SLIM CHICKENS SITE PLAN

PARKER AND PINE FILING NO. 1, LOT 3

SITE PLAN
SLIM CHICKENS
COVER SHEET

PLANTING PLAN

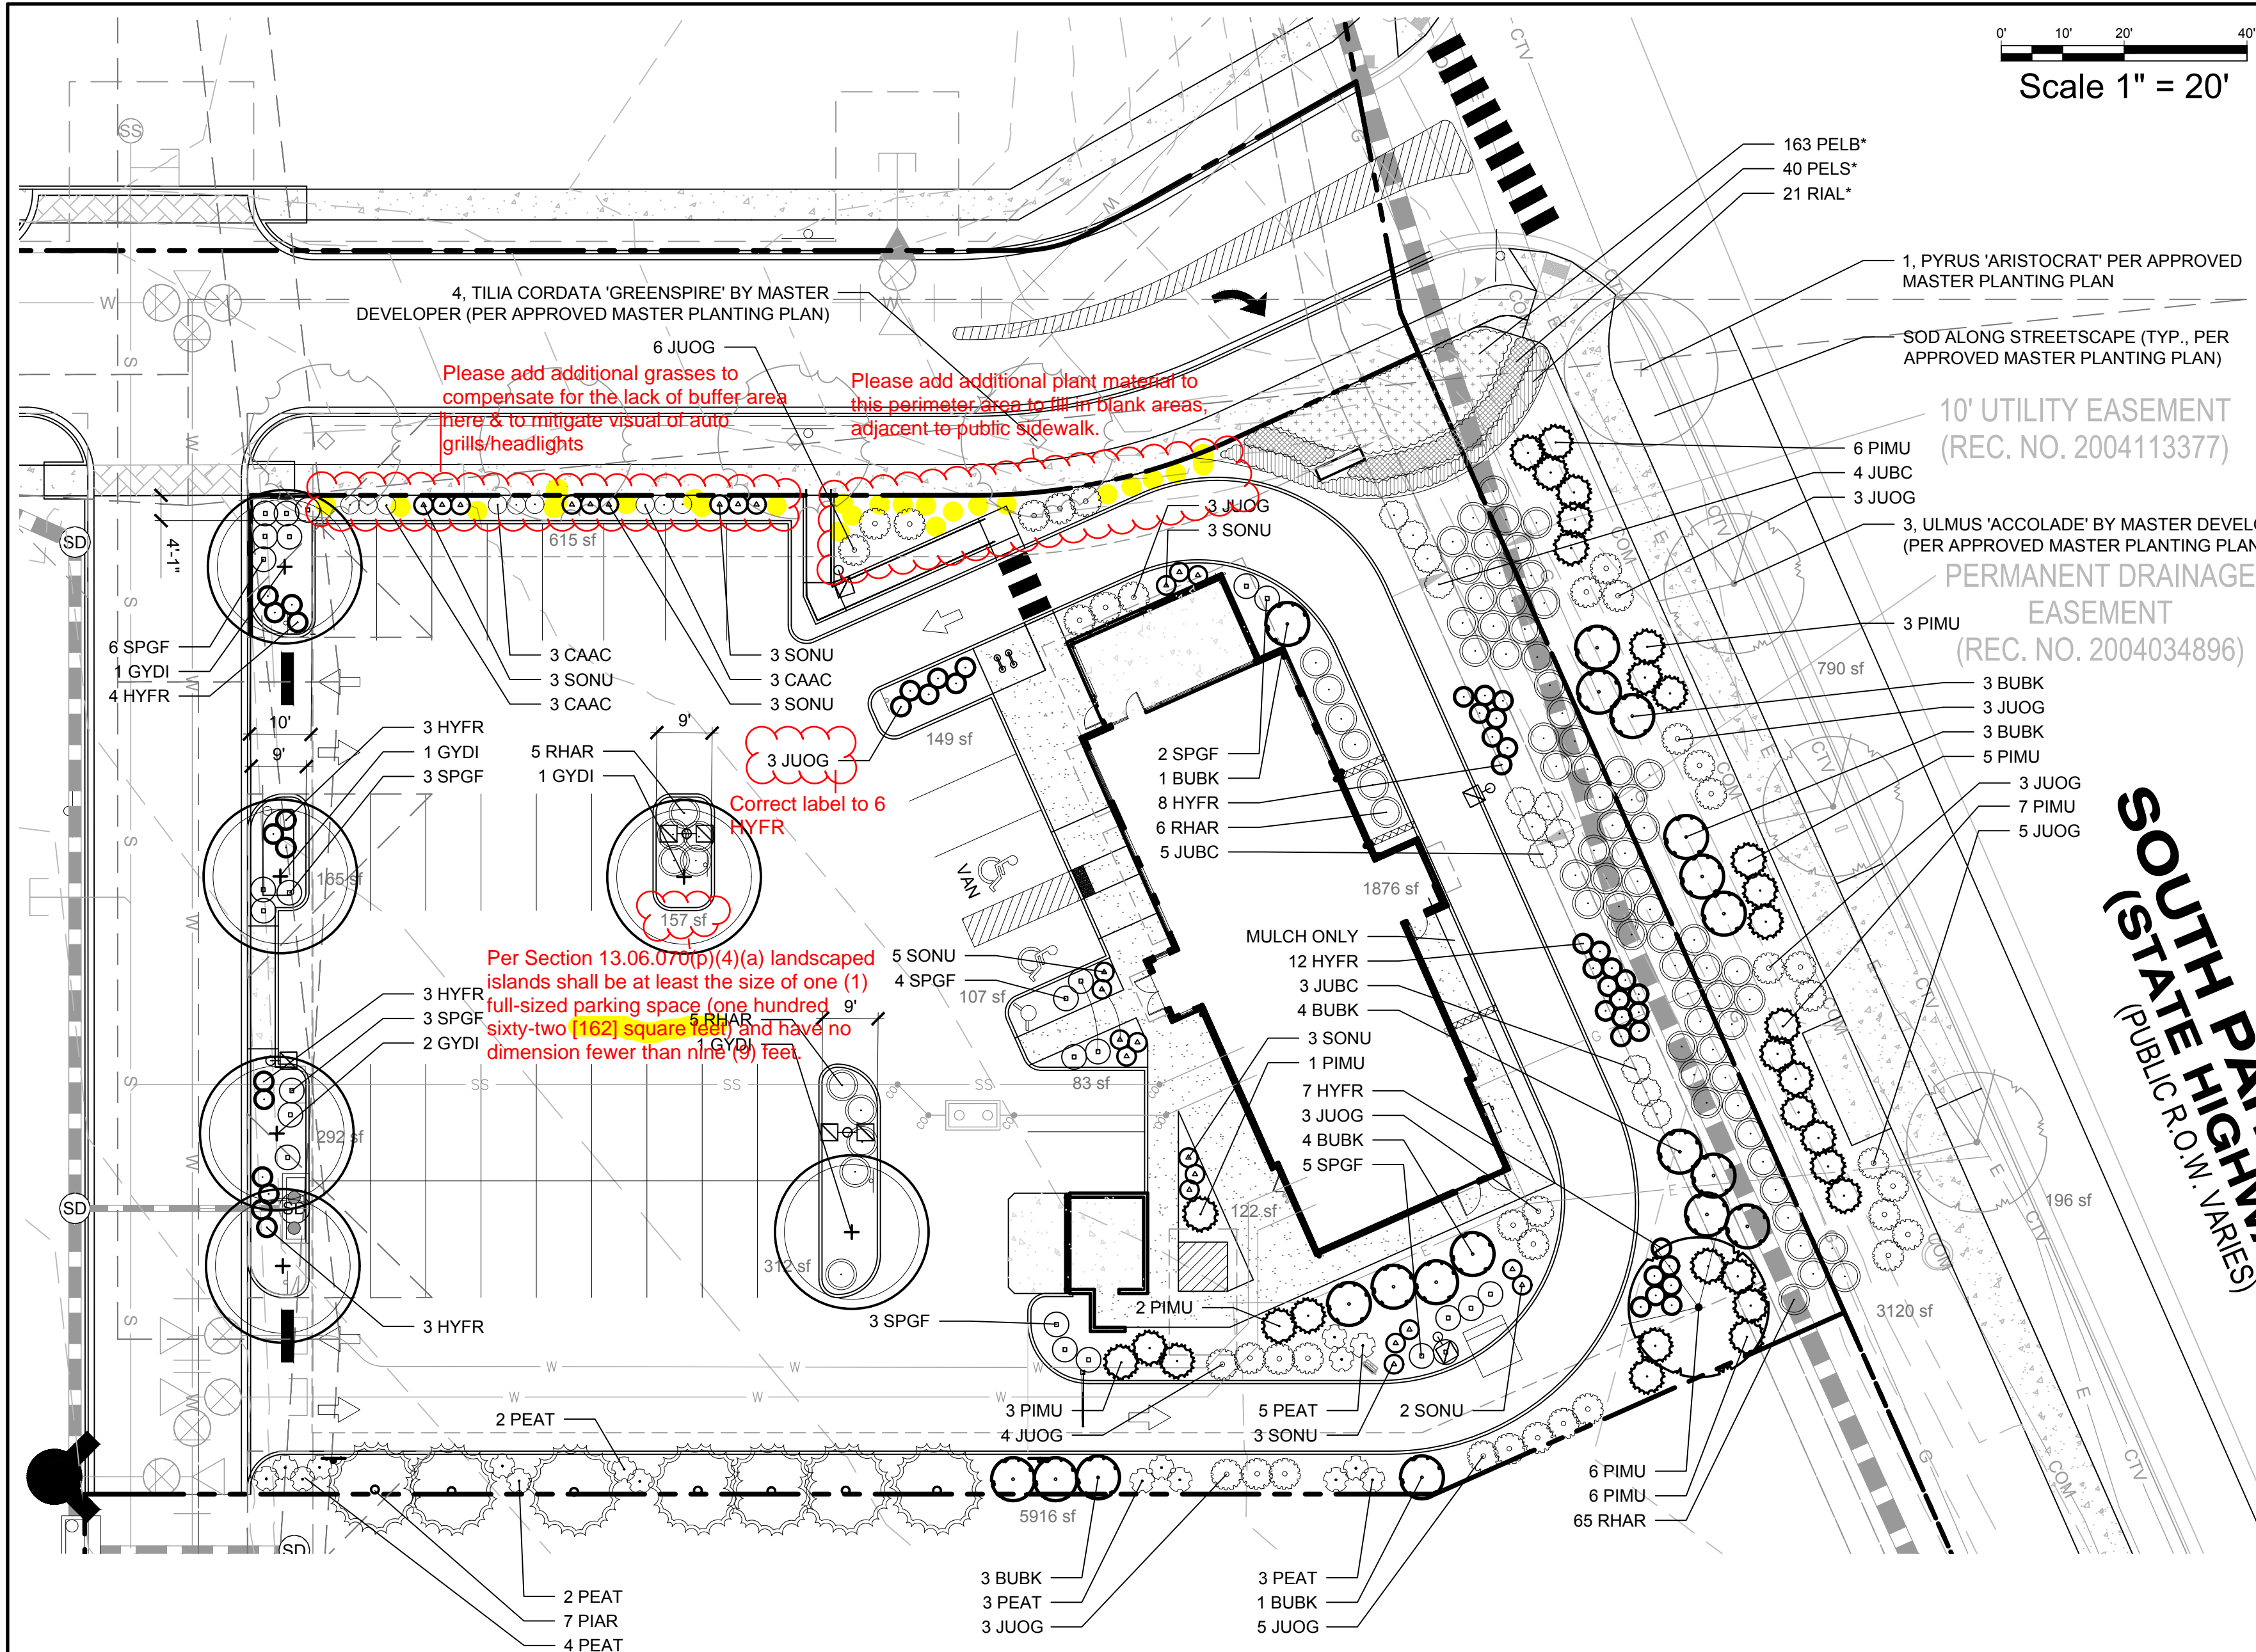
OVERALL SITE LANDSCAPE	PER SECTION 13.06.070
TOTAL AREA: 37,998 SF	All fractional requirements shall be rounded up. Please adjust accordingly. Pls. revise to 7 trees.
TREES REQUIRED: 27 (1 PER 1500 SF OF LANDSCAPE AREA)	
TREES PROVIDED: 23	NOTE: Site Perimeter landscaping are separate/additional requirements.
DECIDUOUS: 14 (66.7%)	
EVERGREEN: 7 (33.3%)	
SHRUBS REQUIRED: 31 (5 PER 1500 SF OF LANDSCAPE AREA)	
SHRUBS PROVIDED: 219 (158 PROPOSED, 61 BY PER MASTER PLAN)

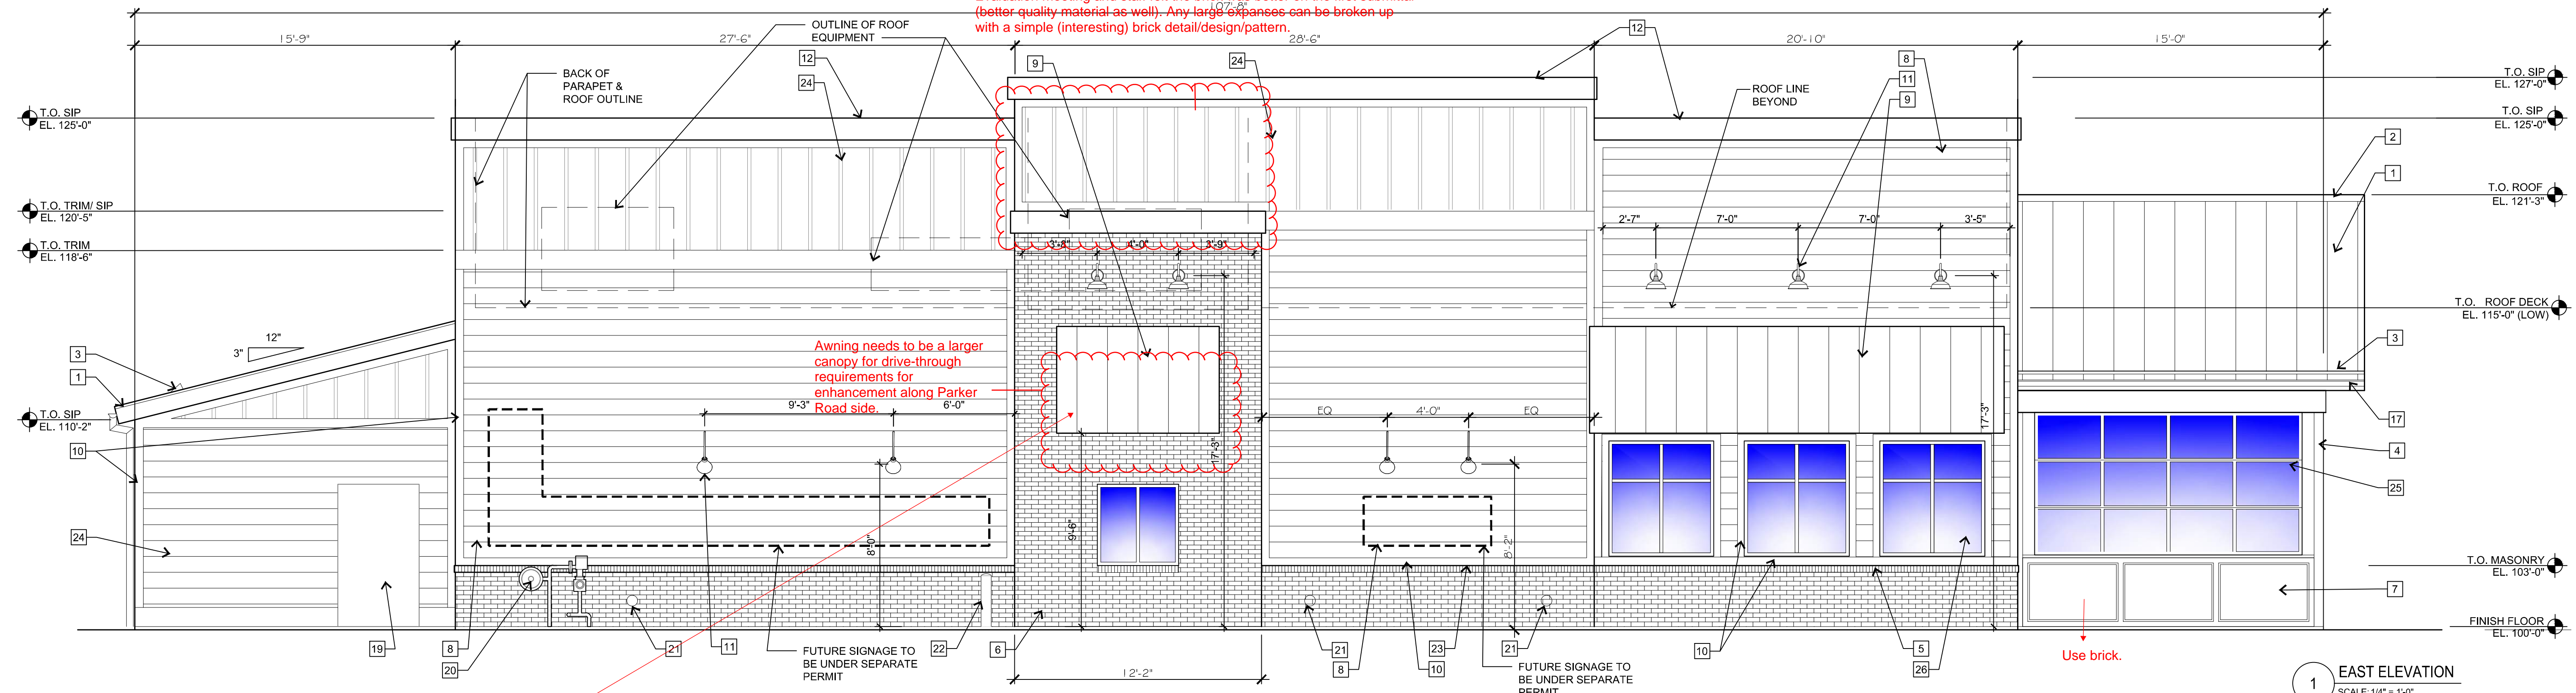
Continue brick to top if this is parapet. Prefer more brick added back as shown on first submittal. You could expand the brick on both sides of the window & all the way to the top. Took this to our Urban Design Evaluation meeting and staff felt the brick was better on the first submittal (better quality material as well). Any large expanses can be broken up with a simple (interesting) brick detail/design pattern.

Use brick.

*** Development Design Standards VIII. Site Design Standards, section F.c.:** When Drive-through windows and facilities cannot be designed to avoid adjacency to public roadways, they shall be covered with a canopy that is integrated into the design of the building and screened with landscaping with an opacity of 80% at one (1) year maturity, a maximum of three (2) feet in height, or screened by a decorative solid wall with a maximum of four (4) feet in height. Please describe how this requirement will be met.

**Need to see revised colored renderings

2 SOUTH ELEVATION
SCALE: 1/4" = 1'-0"

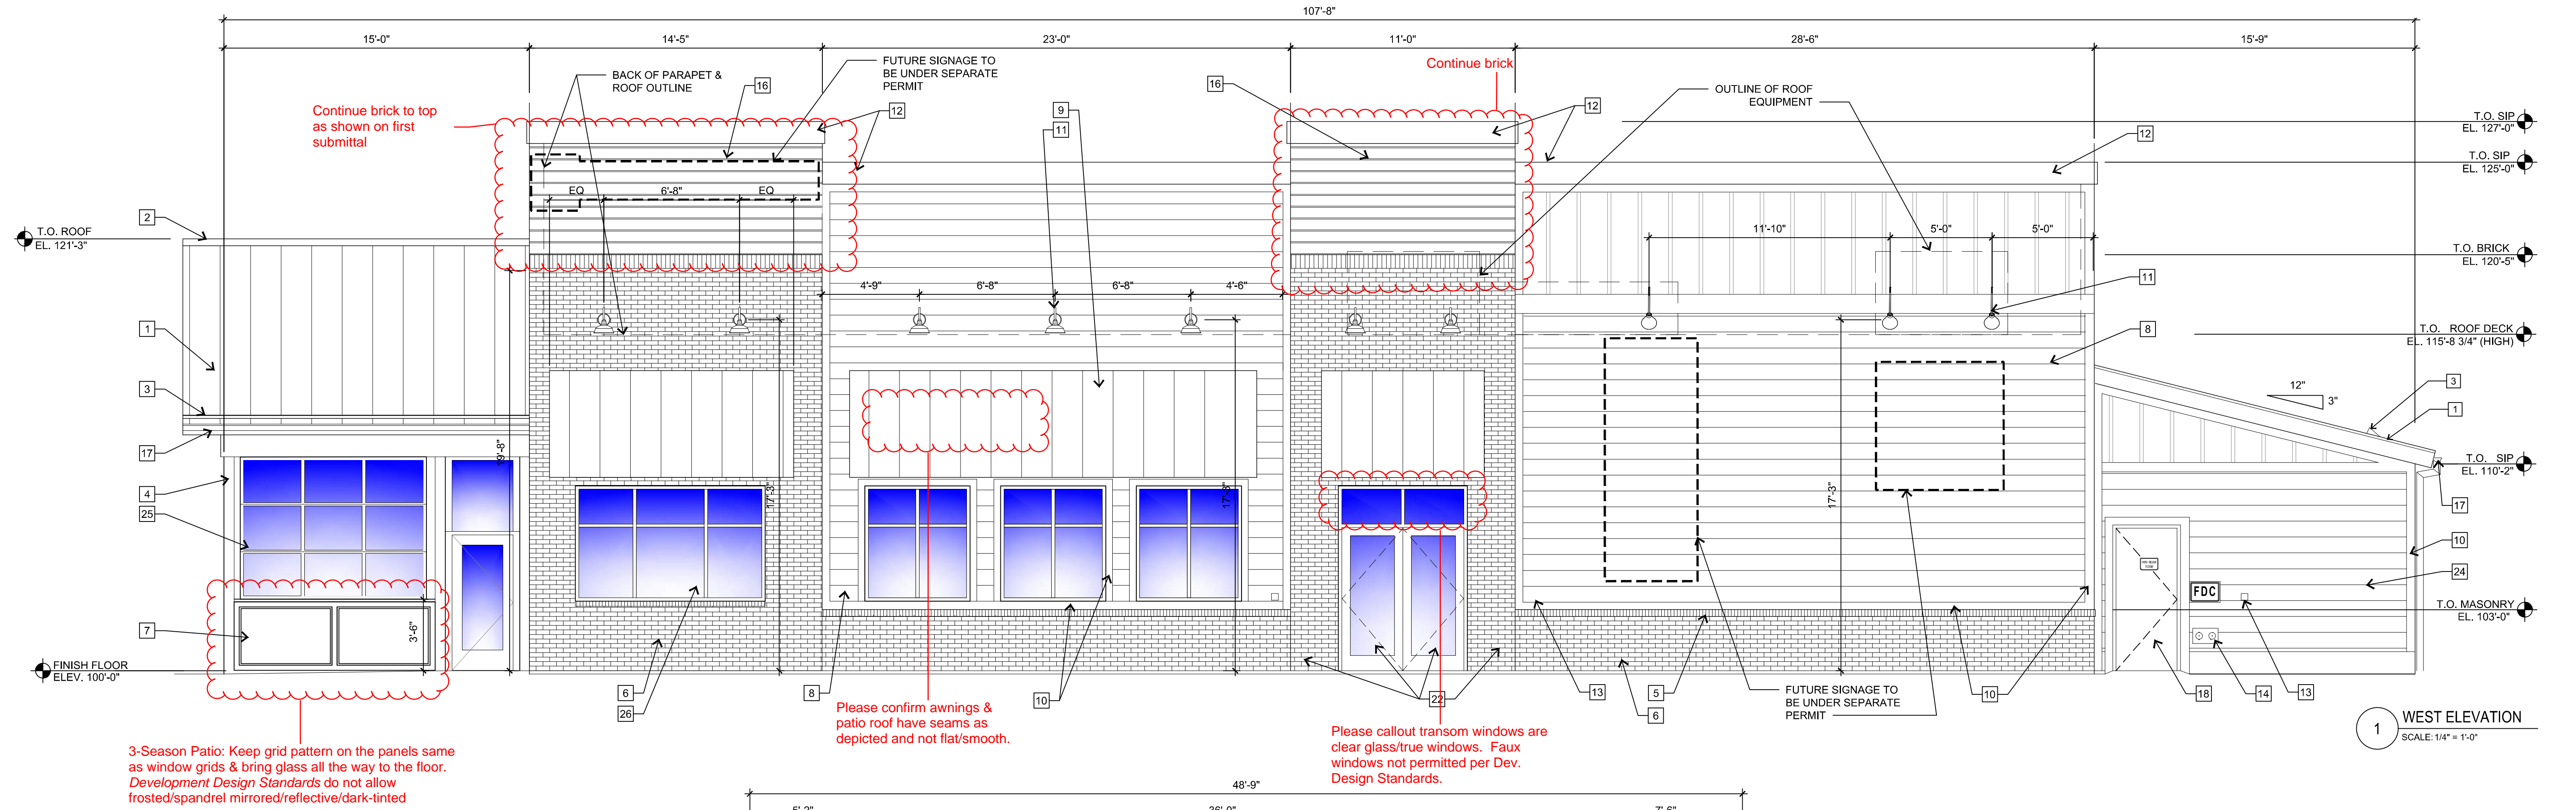
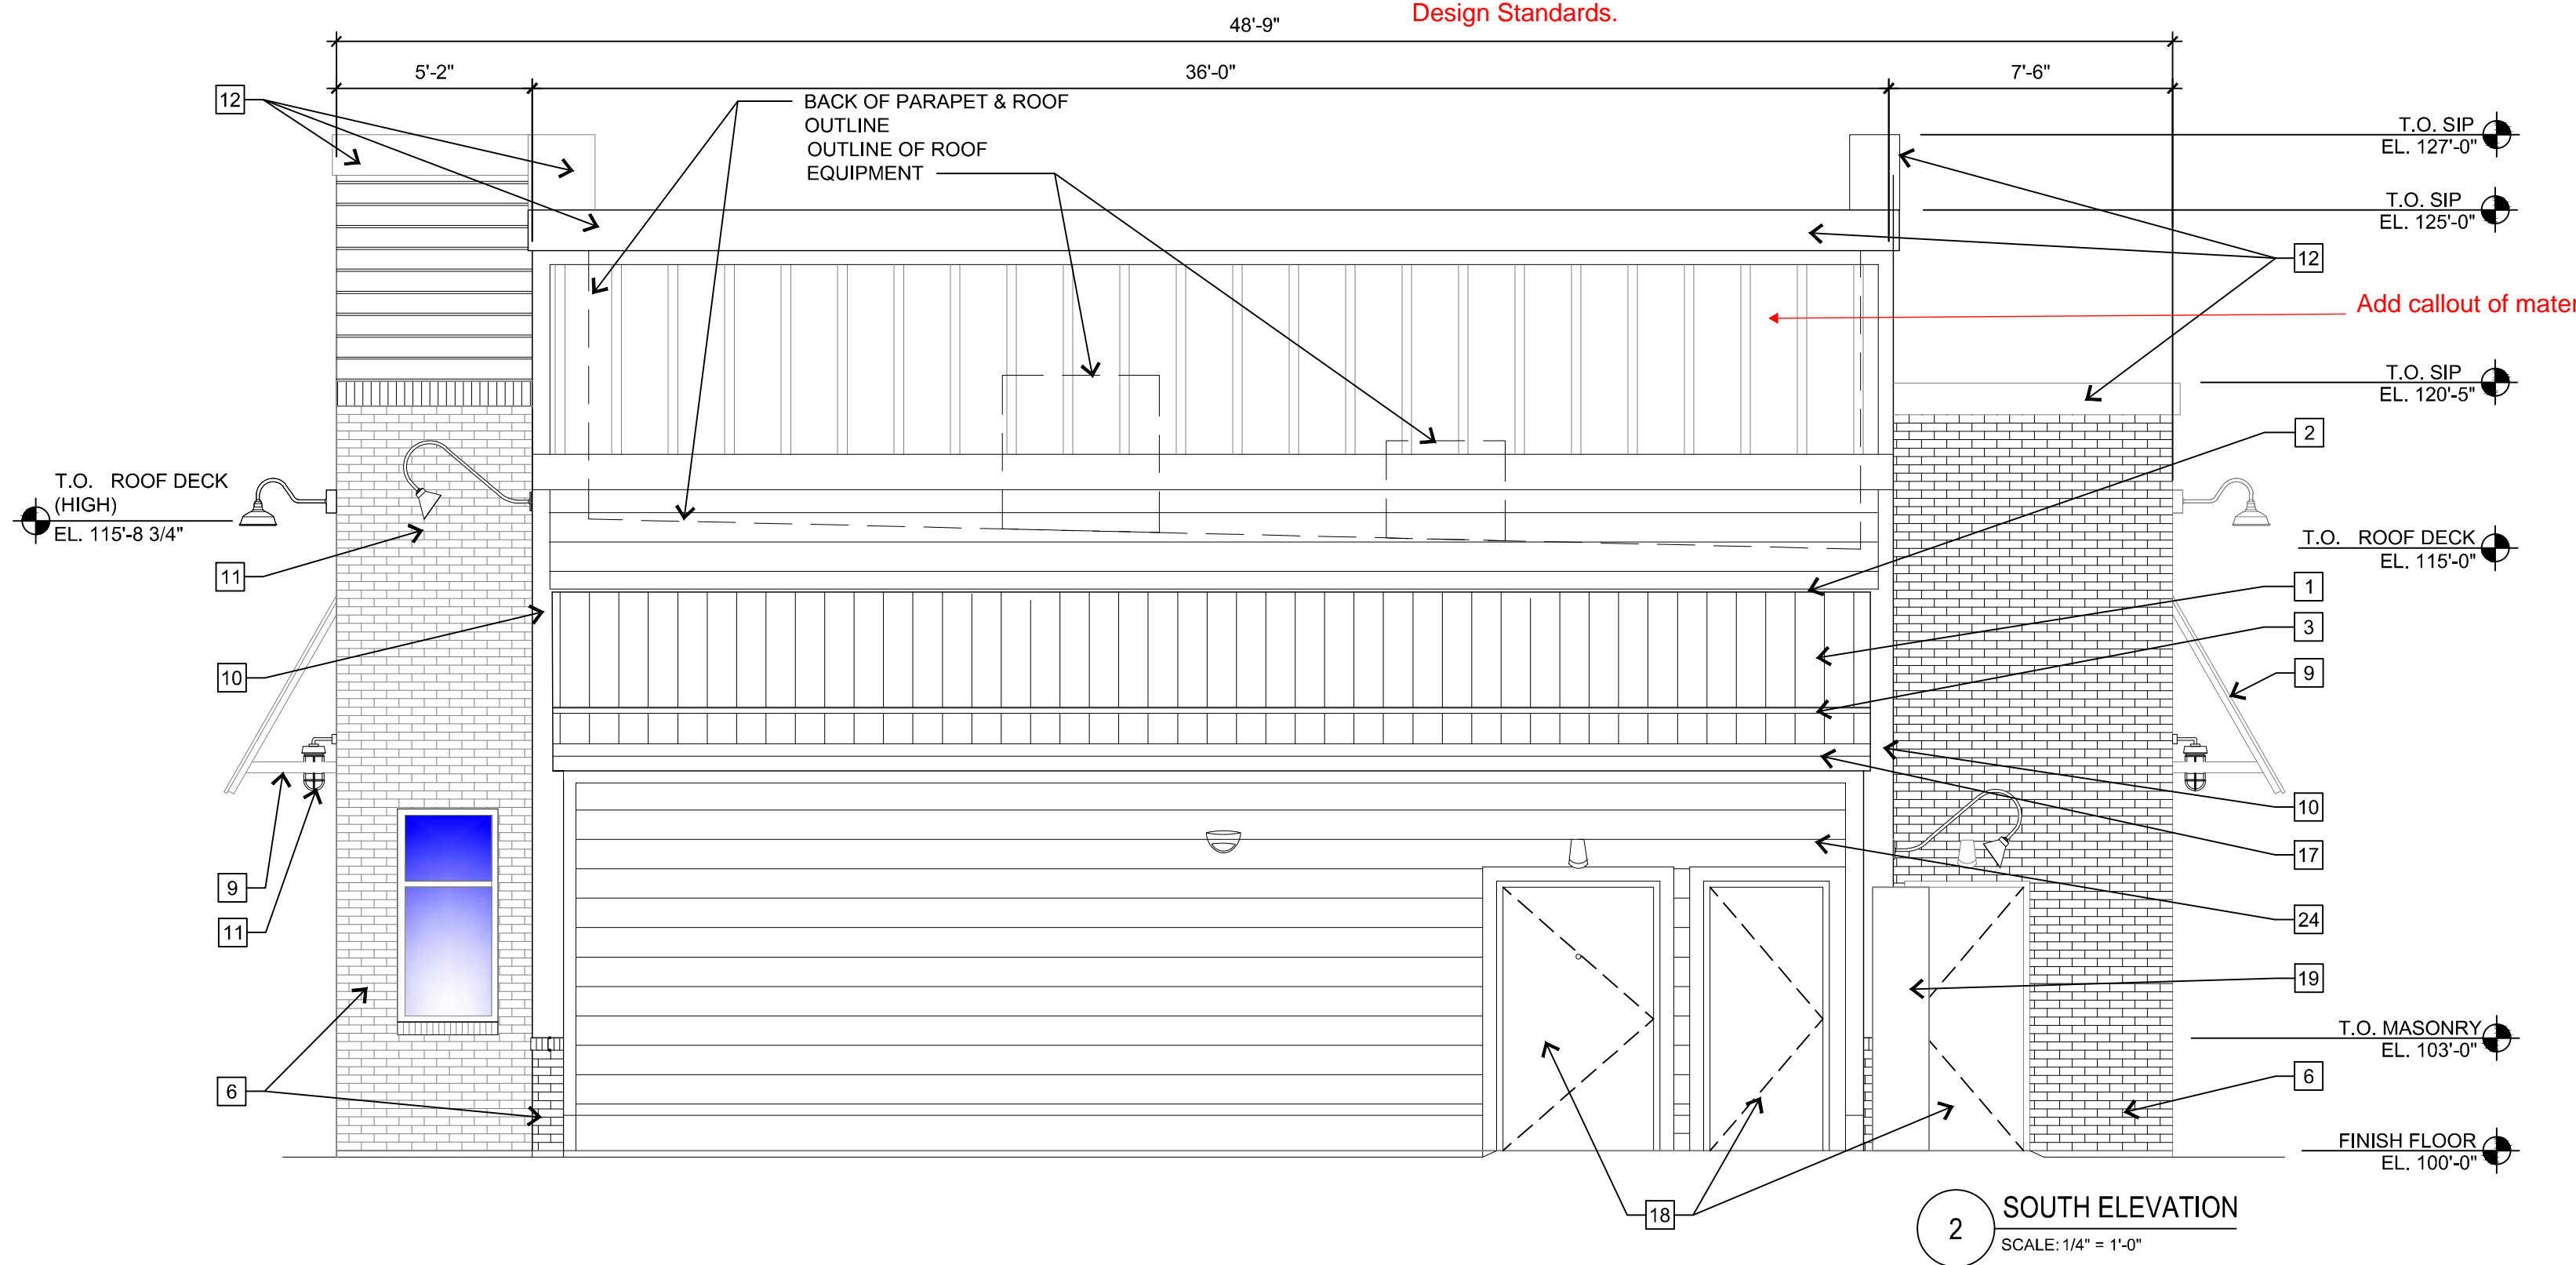
- Please provide detail of trash enclosure. Also include trash enclosure in revised colored rendering/elevation.
- 2. Please show proposed screening of the electrical cabinet on the site plan, landscape plan and elevations.
- Provide a diagram showing the wall plane changes with distances and depths. See page 53 of the Development Design Standards for required plane changes to confirm compliance.
